Subject	Briefing Note to Sydney North Planning Panel
Property	Nos. 22-44 Berry Road, 21-21 Holdsworth Avenue and 42-46 River Road, St Leonards
Description of Proposal	Demolition of existing structures and construction of five residential flat buildings comprising a total of 238 apartments and basement parking for 411 vehicles
Council/Panel Application No.	DA60/2022 / PPSSNH-316
Lodgement Date	1 June 2022
Indicative Determination Date	First quarter of 2023
Capital Investment Value	\$138,059,712.00
Applicant / Owners	Helena Miller (MG Planning P/L) (Applicant) CIFI St Leonards P/L and Greateon St Leonards Holdings P/L (Owners)

Figure 7: Incentive Height of Building Map

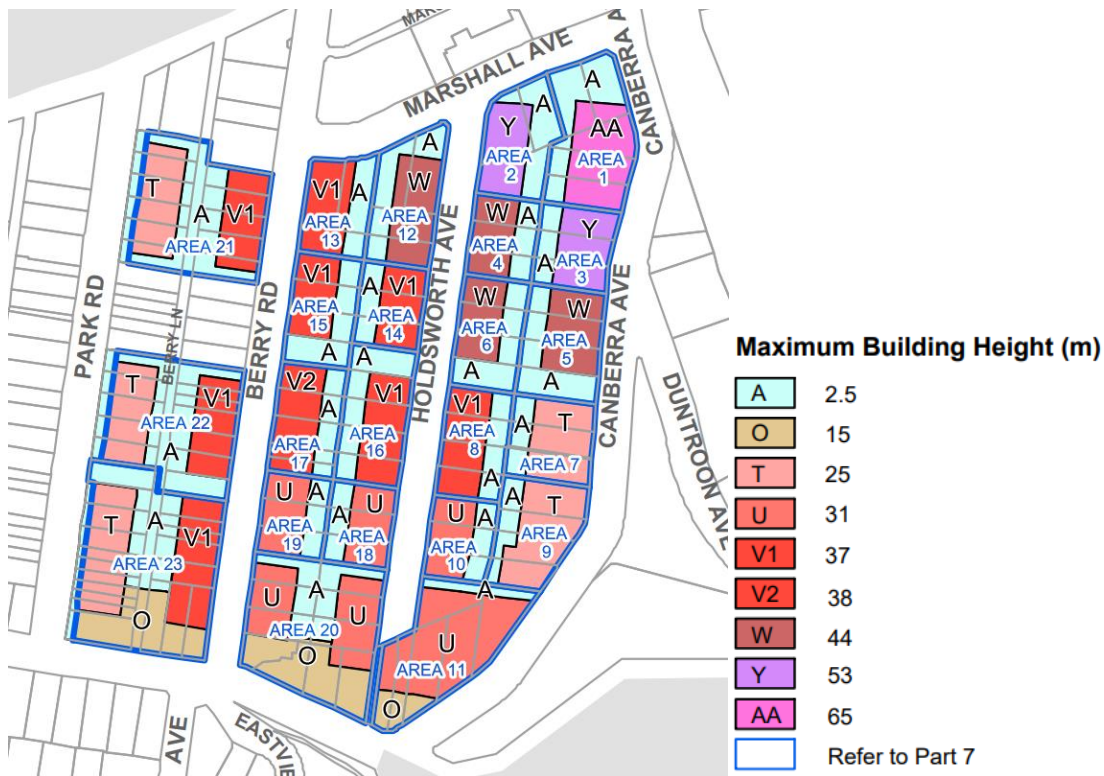
It is advised that the proposal contains building elements such as slab, fin and planter box elements encroaching into the required 24m wide green spine would be contrary to the maximum 2.5m green spine building height development standard under the LCLEP 2009 and it was requested that these elements be deleted. . In response the applicant has provided the following justification/s as follows:

Comment: It is noted that a review of the amended architectural and landscaping plans indicates that there are still building slabs and planter box still encroaching into the green spine area over the maximum LEP 2.5m building height zone. The submitted legal advice is not agreed with and it is strongly recommended that there be no building encroachments into the green spine area. This outcome would not be unreasonable as other approved and proposed developments within the Precinct have fully complied with this requirement.

The amended architectural plans at Attachment 2 provide a separation between Buildings A and D and Buildings B and C of 24m from all structural amendments of the buildings. This is as per Council's 'shape file' which it is understood details the location of the 2.5m maximum height zone set out on the LEP map. The design has been amended so that the building slabs edges have been reduced by 50mm such that they do not protrude into this area.

Accordingly, the only remaining projections above the 2.5m maximum height zone are lightweight non-structural screening elements attached to the building's but which do not form part of the structure of the building. These elements do not extend to the ground below and are merely add on elements to improve the appearance of the buildings and the internal amenity of units by providing shading. They are not therefore measured for the purposes of the height control. This is standard planning practice and has been confirmed as a correct interpretation in legal advice provided by Corrs Chambers Westgarth.

It is therefore considered that there is no height non-compliance in respect of the LEP height limit within the 2.5m green spine zone and that there is therefore no impediment to the proposal being approved with the subject fin elements and above ground planter boxes projecting above the green spine zone.
